ASPEN HISTORIC PRESERVATION COMMISSION

January 22, 2025

XIII.A Resolution #__, Series of 2025 - 337 Lake Ave Certificate of Appropriateness for

FROM: Gillian White, Historic Preservation Officer, Principal Planner

Figure 2: Comparison of Lot A (historic) and Lot B (new) front facades.

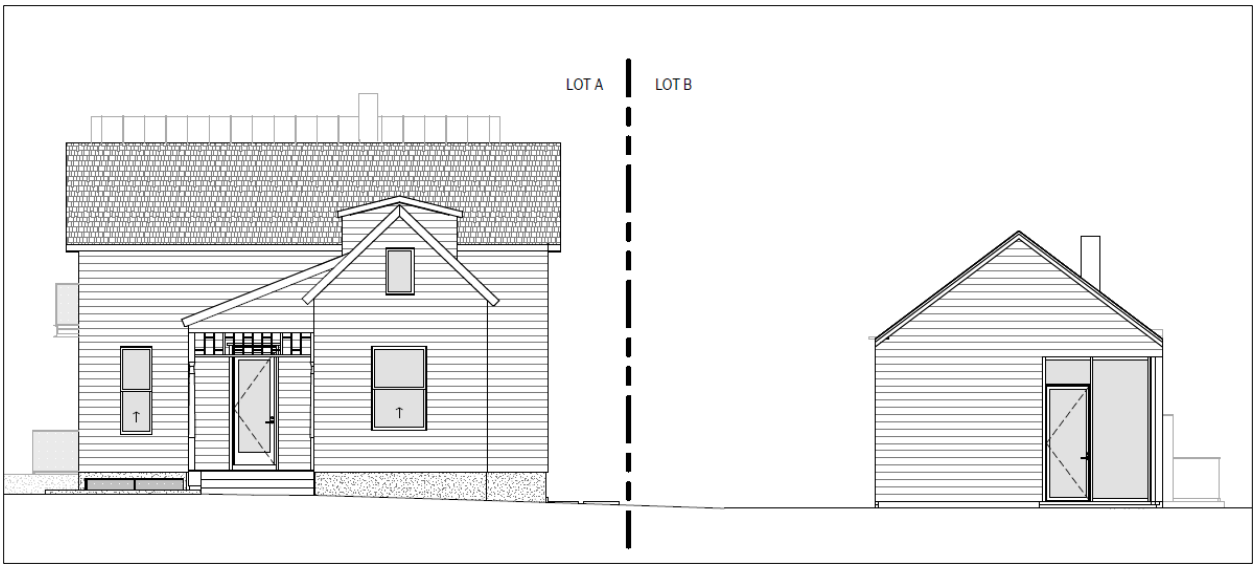
11.4 Design a front elevation to be similar in scale to the historic building.

Response – The front façade of the new building is not taller than the historic structure as shown in Figure 2 .

MATERIALS PLAN

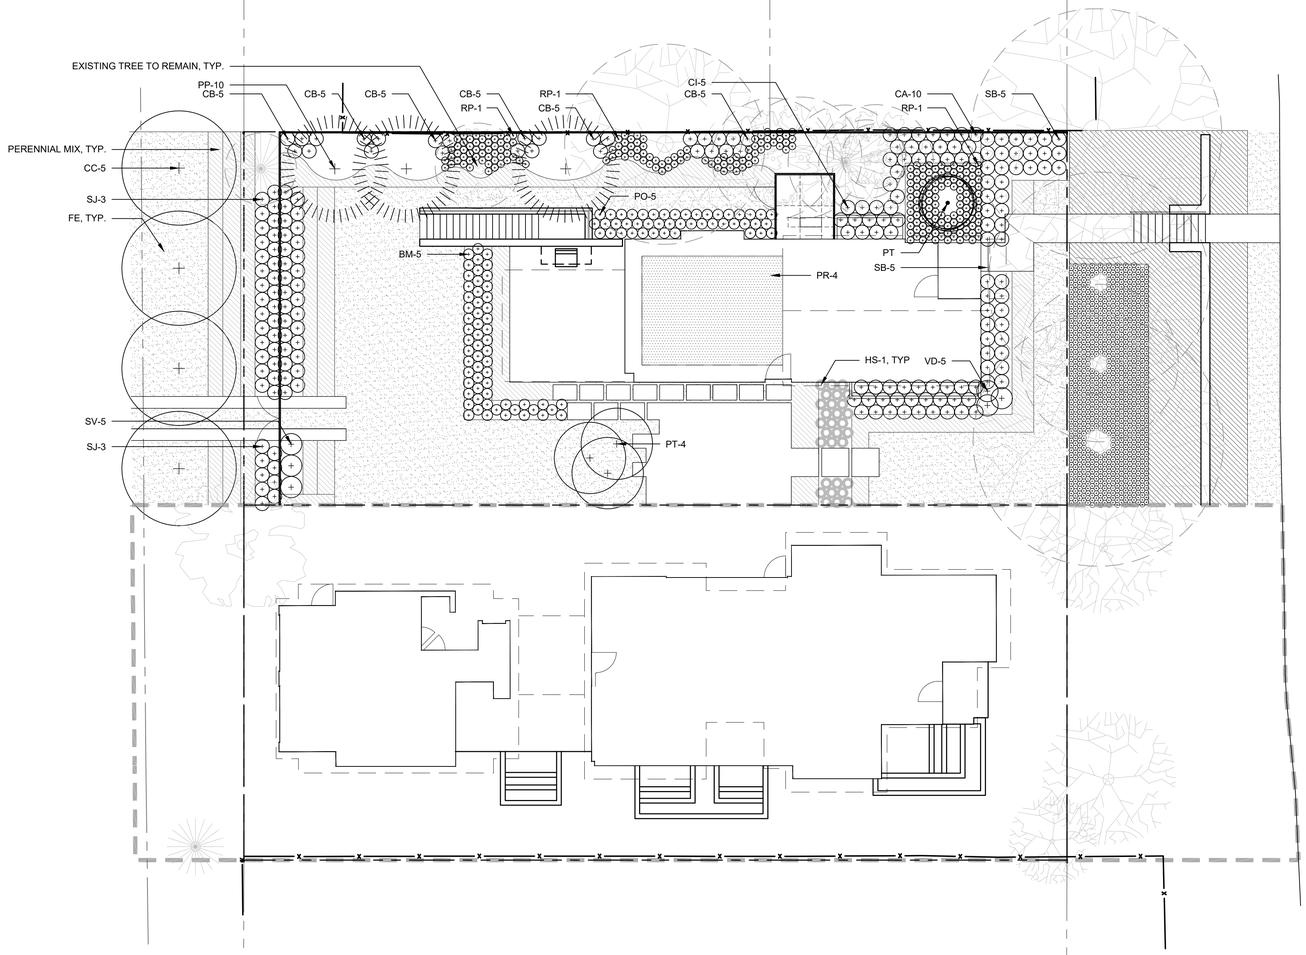
1. Preliminary material representations are requested when available.
2. Sheet LX-01 shows the retaining wall partially on 335 Lake Ave property – are you only demolishing to the property line?
3. Please include photo of the existing retaining wall.
